# REPORT TO COUNCIL

**Application:** DP17-0066 & DVP17-0067      **Owner:** City of Kelowna

**Address:** 1580 & 1558 Ellis St      **Applicant:** Mission Group (Luke Turri)

**Subject:** Development Permit and Development Variance Permit

Figure 3: Final Proposed Design

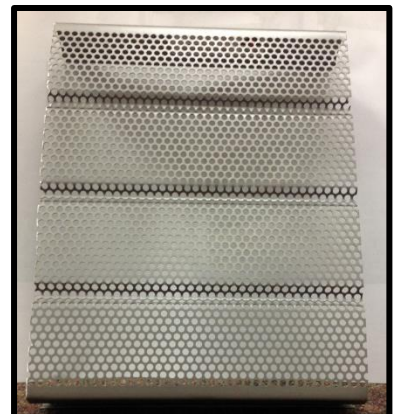
Staff felt that either solution was acceptable as a parking relaxation would likely be appropriate considering the downtown location of the project. The applicant was not willing to consider these alternate solutions as the overall cost to the project may increase and the amount of parking was a key consideration for the developer in their proposed marketing plans. The 5 storey podium contains 22% (31 stalls) more parking than the City's minimum parking requirements. In order to address Staff's concerns and meet the OCP's Urban Design Guidelines, the applicant has concentrated on design solutions to help mitigate the overall scale and height of the podium. The images below illustrate how the evolution of the podium design has progressed over the past few months.

Specifically, the final podium design includes these features:

- Attempted to meet the setback requirement above 16.0 metres on the Lawrence Avenue and Ellis Street facades by stepping back 1.0 metre instead of 3.0 metres.

Figure 4: Proposed  
Aluminium Mesh Panelling

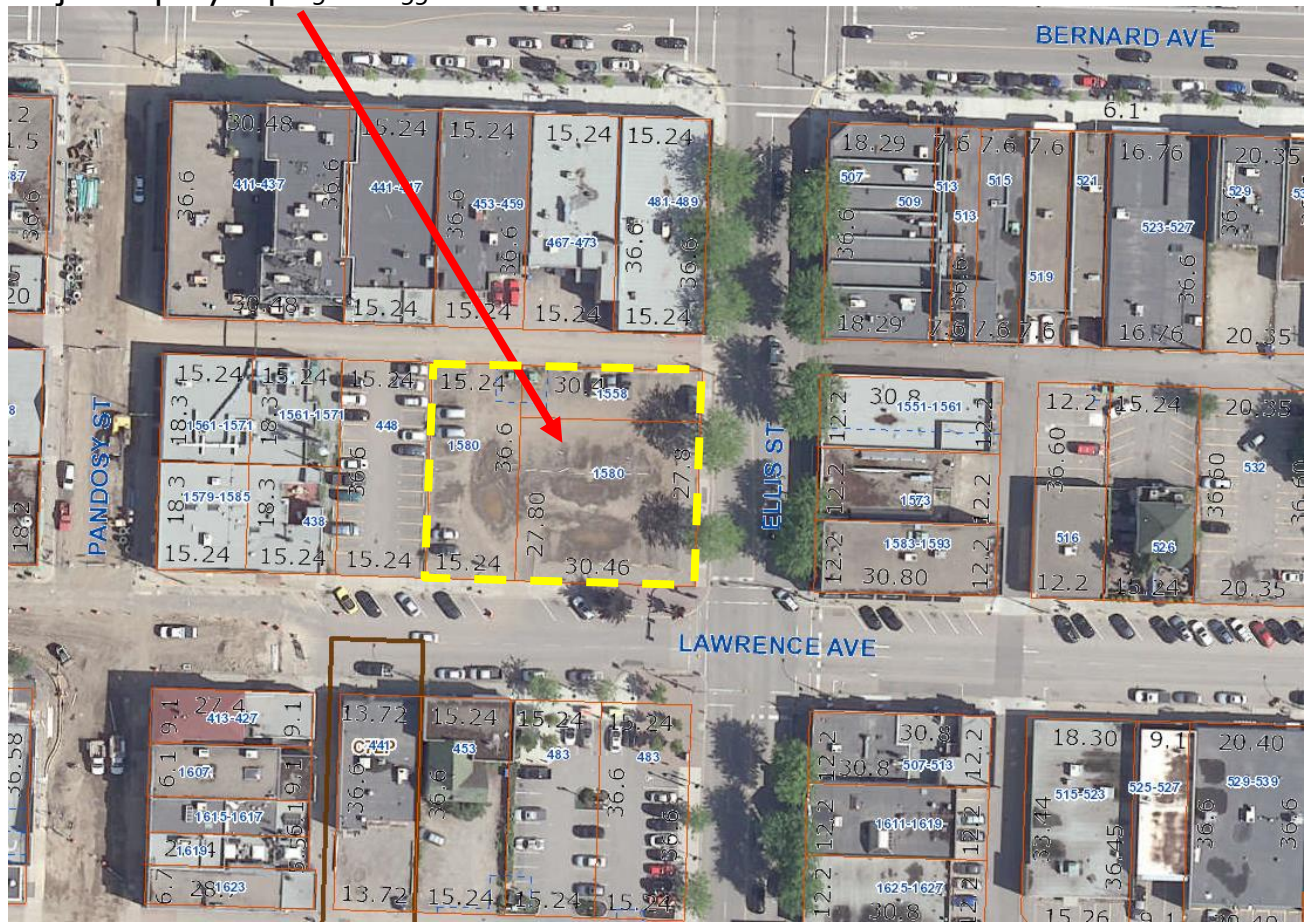
- Another design concern is the aluminum paneling instead of glazing within the 'window wells' along the Ellis Street and Lawrence Avenue facades (on floors 3 to 5). The 'window wells'

are inset within the elevation which provides a positive architectural response but the concern is the aluminum panels will appear solid from the pedestrian realm rather than providing a reflective glazing finish. See figure 4 to see the sample material.
